Annotated Marked-Up Drawings

1/10
DORIS ET AL.
JPA FIS920030264US1

FIGURE 1

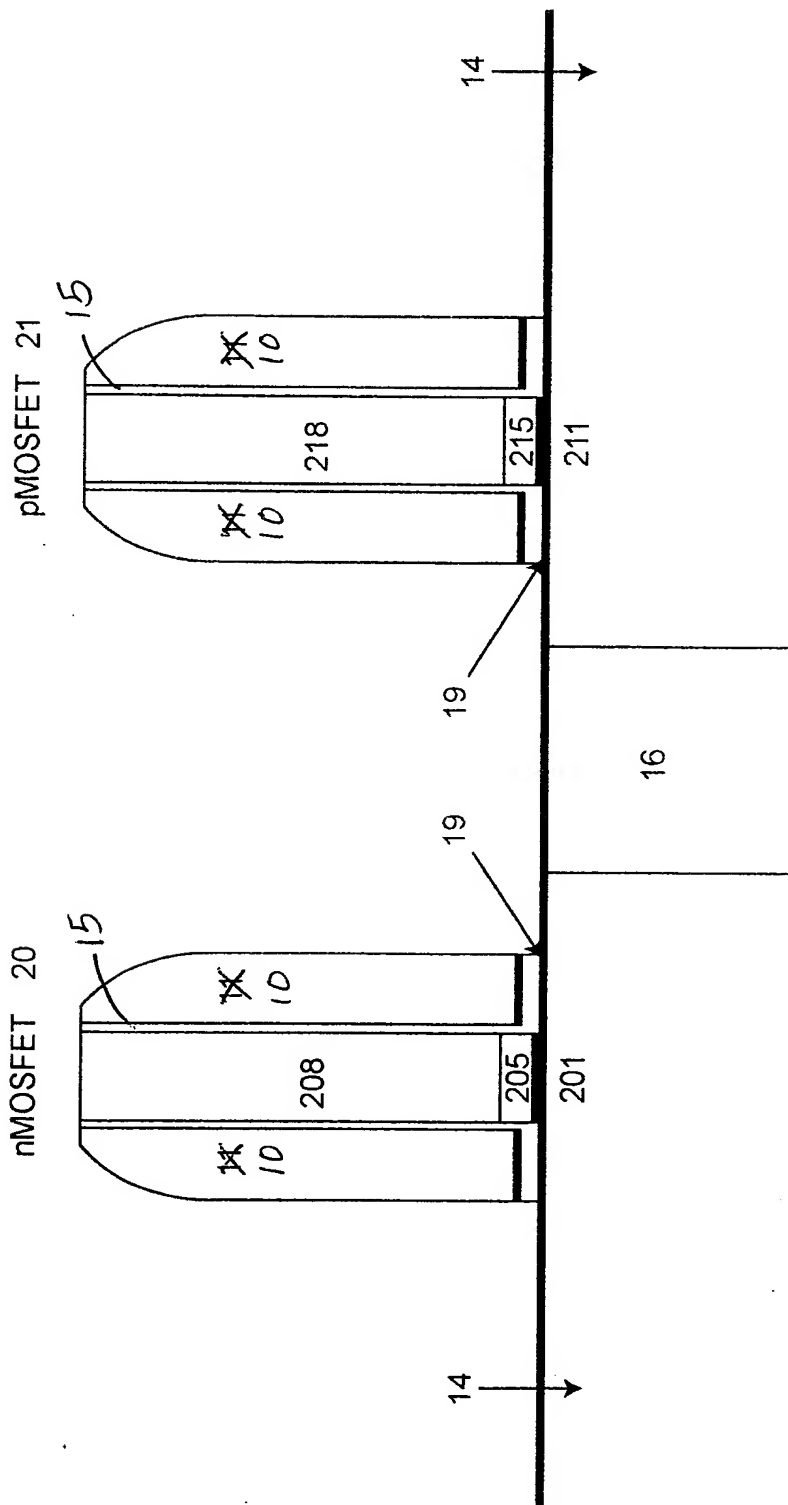
Please approve the proposed drawing changes shown in red on the attached copies of drawing sheets containing Figures 1, 2, 4, 5 and 9/8C. Reference numbers are revised in Figures 1, 2, 4 and 5. The drawing figure labeled "Figure 9" has been corrected to identify the Figure as "Figure 8C", as identified in the original application papers. No Figure designated as "Figure 9" was originally filed. Replacement sheets of formal drawings containing the changes are concurrently filed herewith.

The Examiner has objected to the drawings as failing to illustrate the recited source drain and gate silicide. This objection is respectfully traversed since these claimed features are, in fact, illustrated. Reference numbers have been revised in the specification and, in some cases, applied in the drawings to clarify the illustration thereof. Additionally, since it appears that the term "silicide" (being a common feature of many known transistor designs) is unnecessary to a recitation of the distinguishing features of the invention, the term
